| Project Title: | Black Rock Geothermal Project (BRGP) |
| Document Title: | Black Rock Geothermal Project Revised General Arrangement Refinement |

Revised General Arrangement Refinement

Black Rock Geothermal Project
(23-AFC-03)
November 17 2023

Figure 2-1R
General Arrangement,
Black Rock Geothermal Project
Imperial County, California

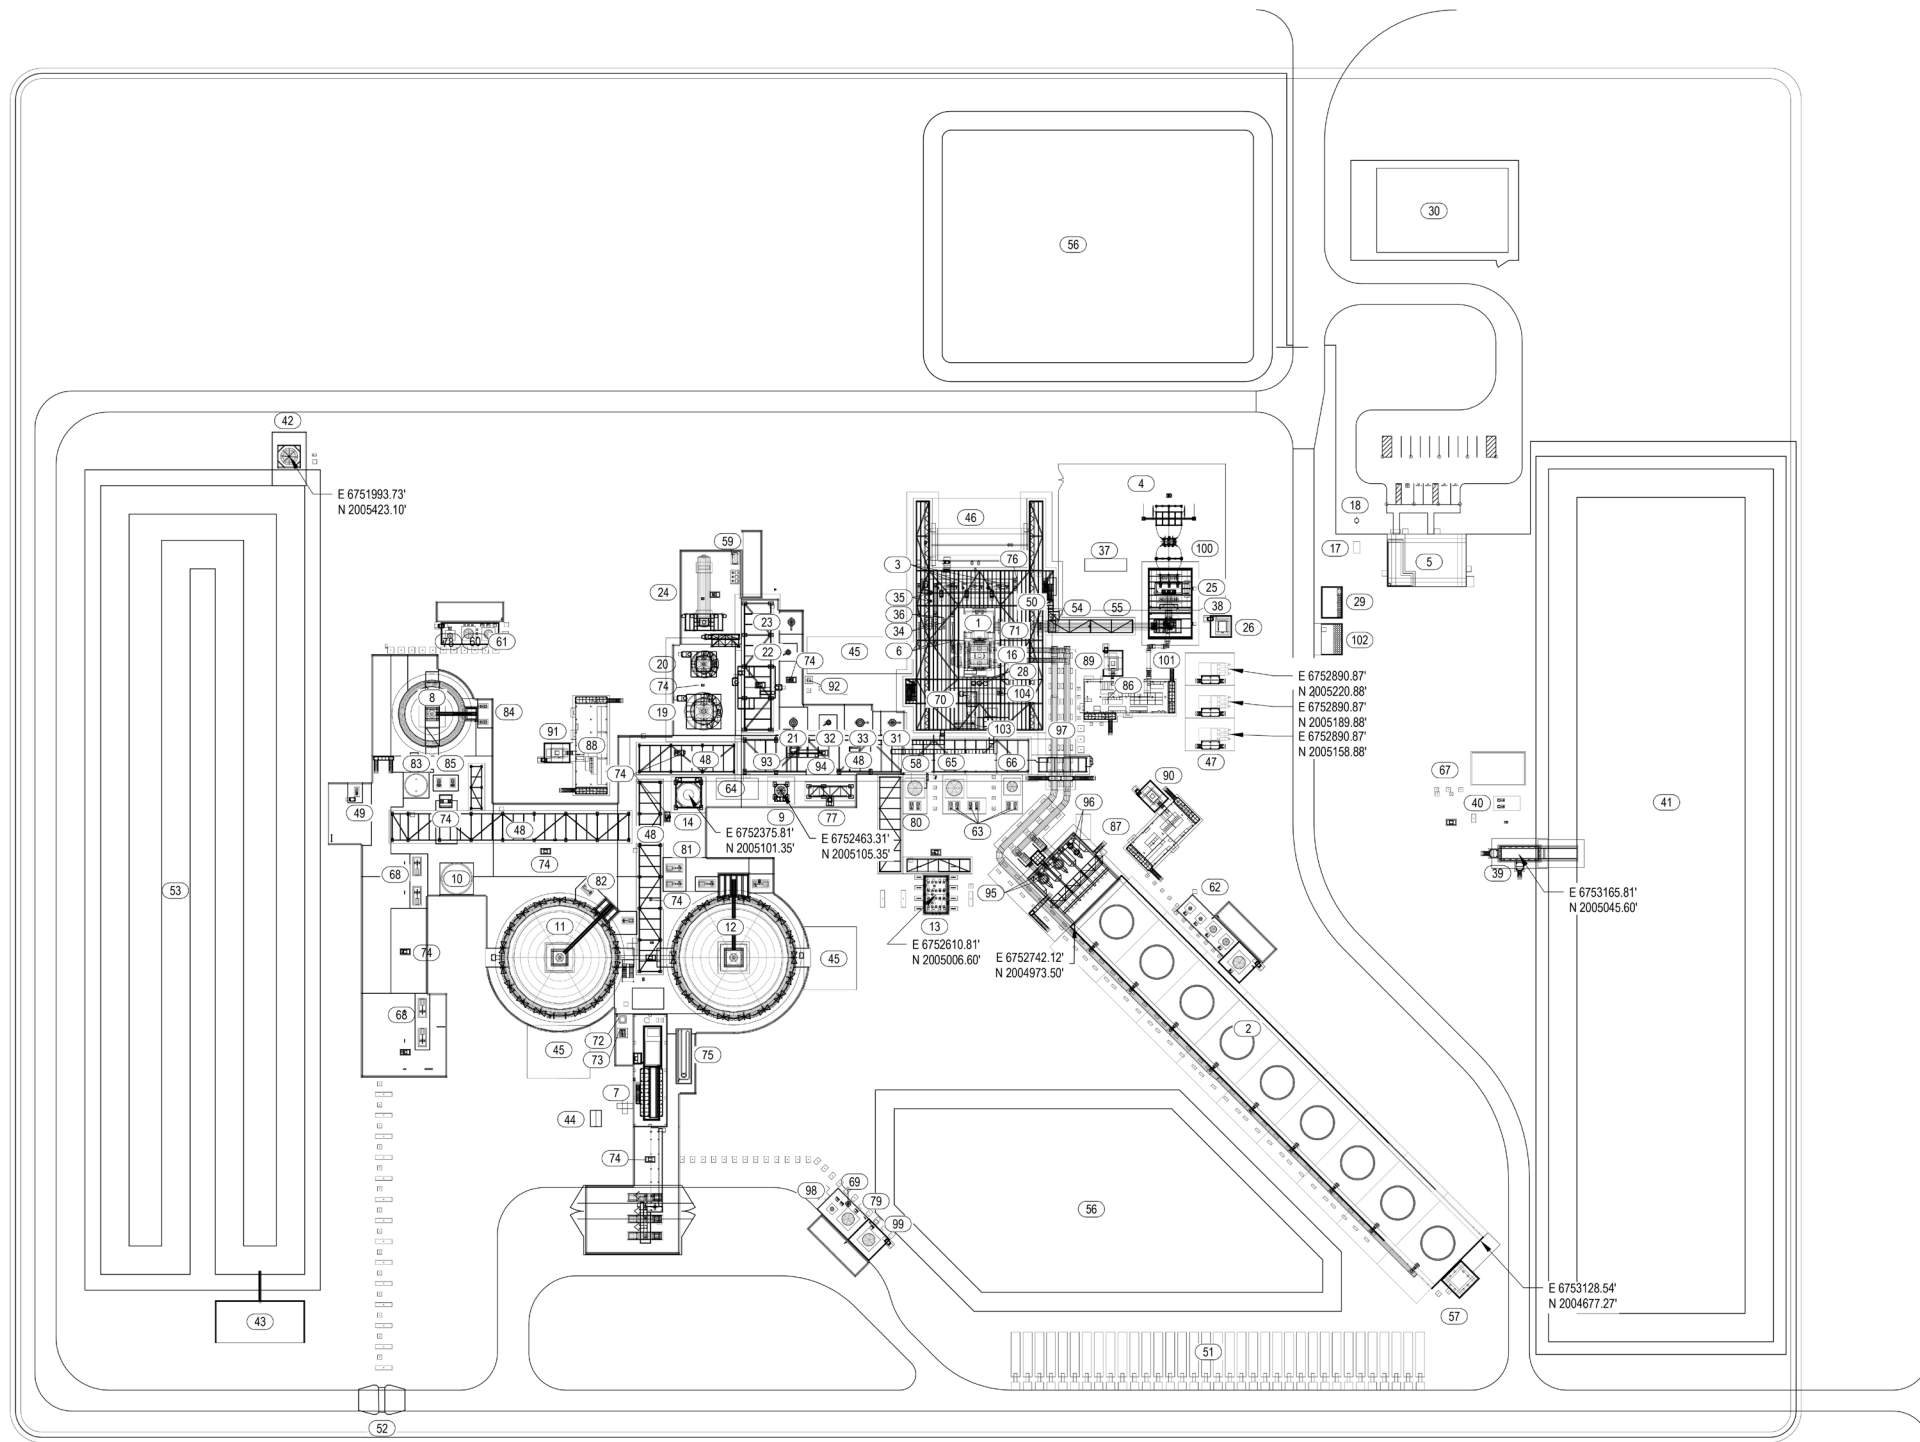
- **Reduced Number of Emergency Diesel Generators:** The number of generators have been decreased from 4 to 3 due to updated operational electrical load information. The generators have been relocated nearer to the medium voltage bus to optimize the design and reduce quantities.

- **Stormwater Retention Basin – Relocated** to be more central to the project site.
- **Change to Storage of Hydrochloric acid (HCL):** Increase the amount of hydrochloric acid (HCL) storage from 1,250 gallons of <37% HCL to one 300-gallon tank of dilute HCL (2.5%) and one 10,000-gallon tank of concentrated HCL (<37%). HCL scrubbing system included on concentrated HCL (<37%) tank.

- **Addition of a 10,300 gallon tank of liquid lime (42-47% Calcium Hydroxide),** used for pH adjustment of the filtrate from Horizontal Belt Filter.
- **Horizontal Belt Filter - Relocated** the belt filter and optimized the truck hauling path to allow for a pull through parking (safer operation) , which also reduces pipe rack and piping lengths.

- **Combination of administration and warehouse buildings-** The administration and control buildings were relocated to allow for stronger security control while allowing for public access and parking outside of the facility's fence line.

- **Power Distribution Centers - Optimized** power distribution centers locations to support updated electrical load locations.
- **Cooling Tower - The cooling tower cells increased** in number from seven to nine, while still fitting within the original cooling tower footprint.

- **Primary/Secondary Clarifiers - The clarifiers arrangements** were optimized to reduce concrete, pipe rack, piping, and electrical quantities.
- **High Pressure (HP) Separators, Standard Pressure (SP) and Low Pressure (LP) Crystallizers - Optimized** the centerlines (locations) of the HP separators to align with the crystallizers, which also reduced pipe rack quantities.

- **Gas Removal System - The gas removal system** was relocated to below the steam turbine, which optimizes the space below the steam turbine.
- **Thickener - The thickener** was relocated closer to the geothermal fluid handling process to reduce pipeline lengths and construction costs.

- **Evapotranspiration Bed - The evapotranspiration bed location** was relocated closer to the control building.
- **Chemical Storage - Chemical storage locations** were optimized for safe loading/unloading and pull through driving/delivery routes.
